**City of Richmond**  
Planning and Development Department

**Report to  
Development Permit Panel**

**File:** DP 09-506909

**Re:** **Application by W.T. Leung Architects Inc. for a Development Permit at 6331  
and 6351 Cooney Road**

ATTACHMENT 3: EDGE CONDITIONS (NORTH PROPERTY LINE) - 8288 SABA ROAD

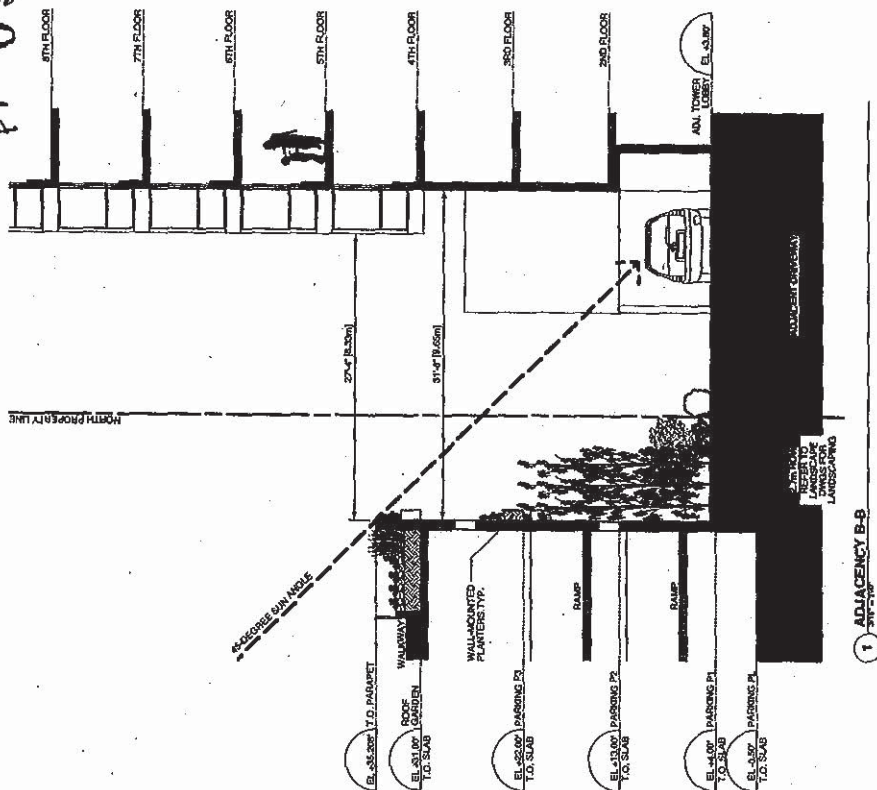
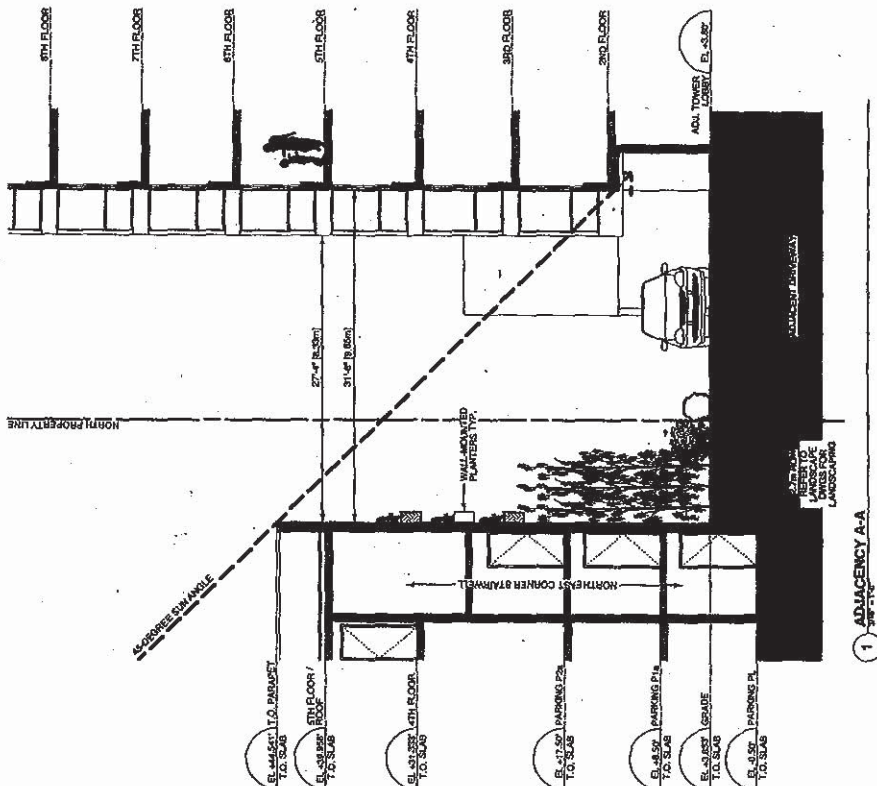
North Edge: The separation from the proposed parking structure and the bay windows of the adjacent residential tower to the north of the proposed development at 8288 Saba Road is 8.33m and 9.65m to the base plane of the tower. The 2<sup>nd</sup> and 3<sup>rd</sup> storey south facing apartment units near the southeast corner of the residential tower located at 8288 Saba Road will directly face the proposed parkade north wall. This interface is being addressed by the proposed development as follows:

- voids or openings in the parking structure walls;
- horizontal planters attached to the parkade walls complete with trellis systems and vines,
- introduction of frosted windows in the stairwell of the parkade,
- tall bamboo planting along the east half of the parkade wall will alleviate views from the lower apartment units in the adjacent residential tower (see **Attachment 3**).

# ATTACHMENT 5: 6371 COONEY ROAD - RE-DEVELOPMENT POTENTIAL

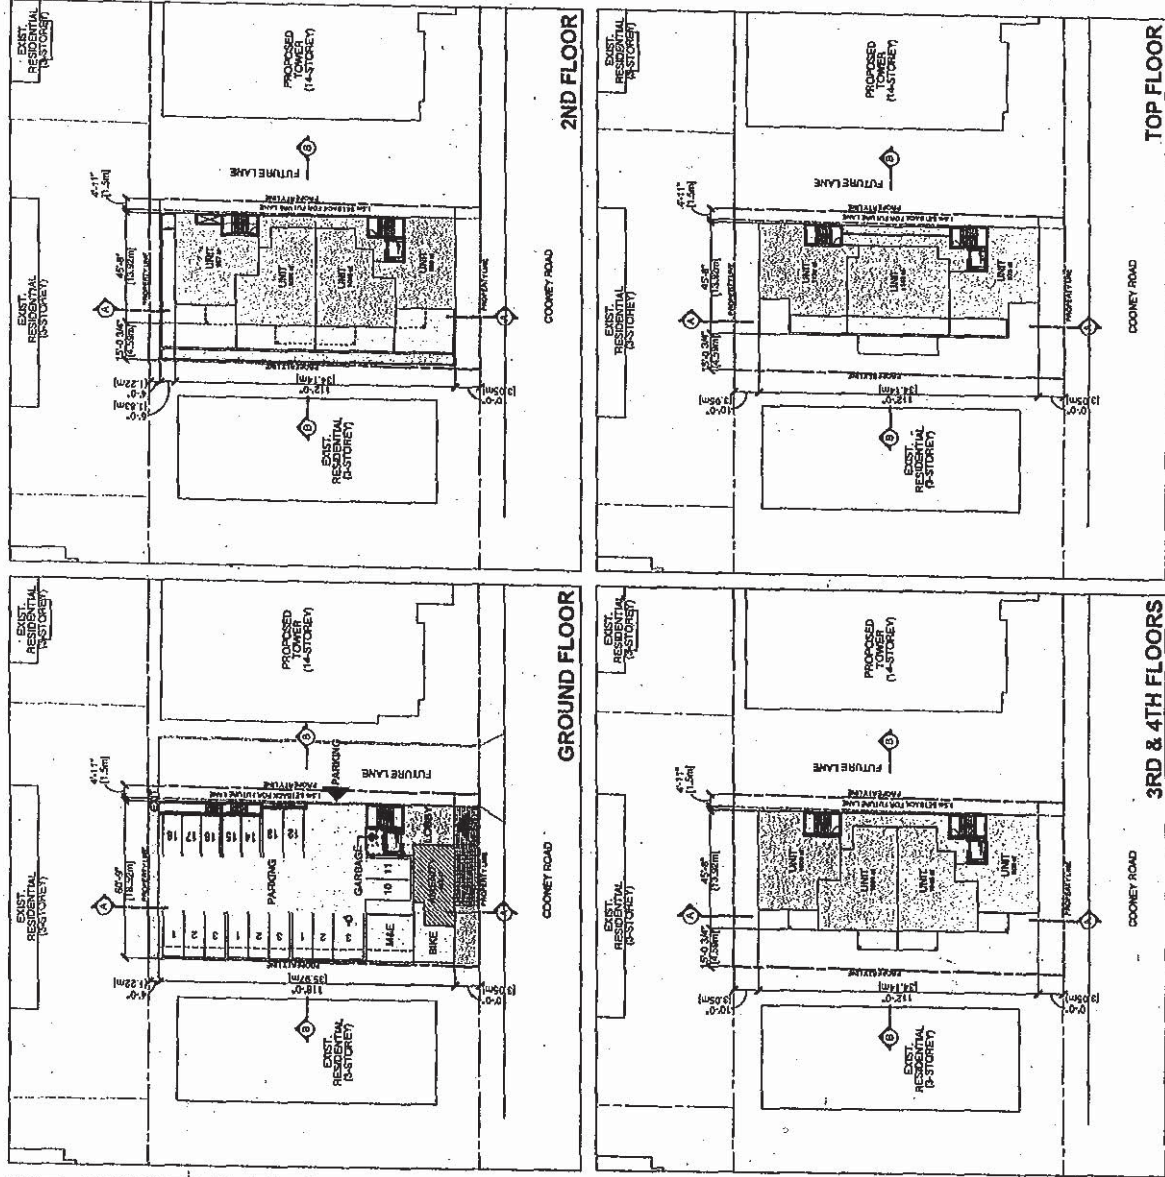
South Edge: The proposed 14-storey residential tower is separated from an older 2-storey single-family dwelling located at 6371 Cooney Road by the proposed 7.5m wide lane along the entire south property line of the subject site. The proposed lane design includes provisions to ensure the temporary retention of 6 existing large trees on the adjacent site that straddle the property line including a low retaining wall, a vehicle restraint barrier, a fence to screen vehicle headlights and unit paving from the ultimate crown of the lane to the south property line. See **Attachment 4** for details regarding the proposed lane design. The proposed development results in one existing single-family residential lot at 6371 Cooney Road to the south of the subject site, which will be temporarily isolated. The Applicant has provided a conceptual scheme that demonstrates the development potential of the 6371 Cooney Road (see **Attachment 5**). This scheme illustrates that the neighbouring property at 6371 Cooney Road could be redeveloped to achieve 2.0 FAR including 15 apartment units complete with the required 1.5m dedication along the north property, which will complete the 9.0m wide east-west lane. Vehicle access to any future redevelopment of 6371 Cooney Road will be via this new east-west lane.

## ATTACHMENT 6: BARRIER FREE ROUTES &amp; CONVERTIBLE UNITS

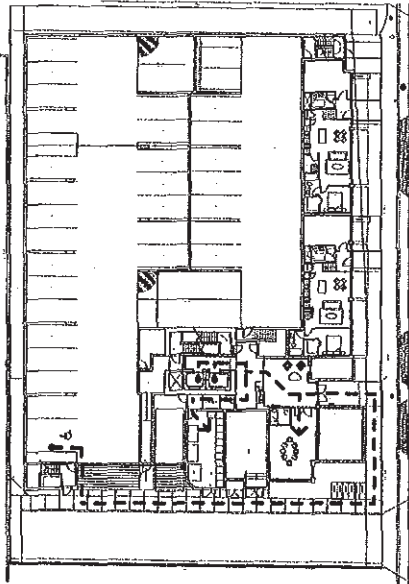
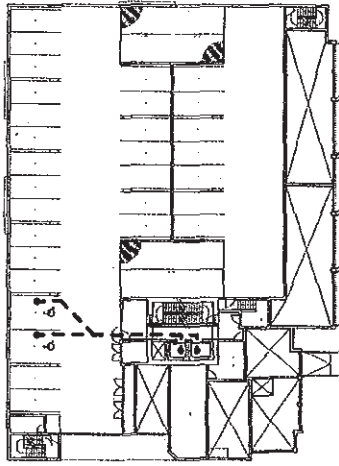
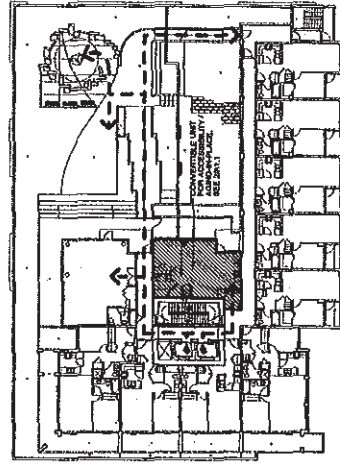
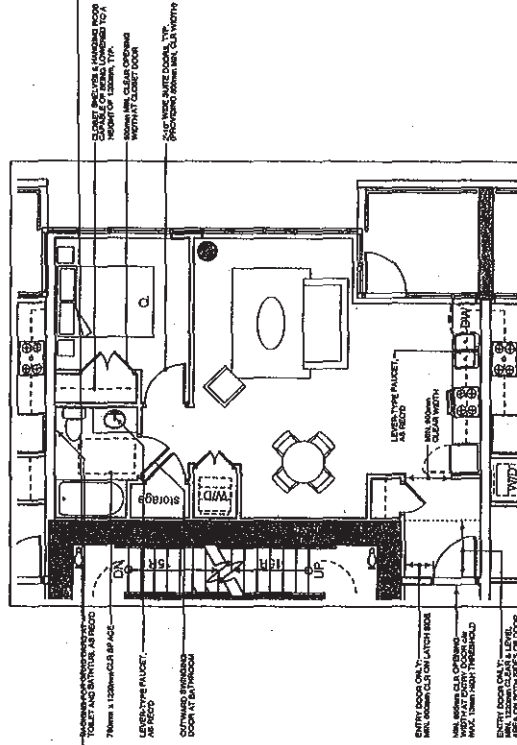
**Accessibility:** Barrier free routes are provided from the wheelchair parking stalls to the lobby, the amenity spaces (indoor and outdoor) and the convertible units (see **Attachment 6**). There are 10 convertible 1-bedroom units provided in this development, which include most of the features required in a universally accessible unit, such as wheelchair turning radii, interior manoeuvring and bathroom transfer space. A minimum level of millwork modification will be required to turn these convertible units into universally accessible units, if desired. In addition, convertible features include an outward swinging or pocket bathroom door, toilet and tub grab bars, lever type faucets, lowered closet shelves and hanging rods and a barrier free connection to the indoor/outdoor amenity space. The design of all units incorporate measures for aging in place including such features as backing for grab bars in 1 bathroom, lever style door handles and tactile numbering of suites.
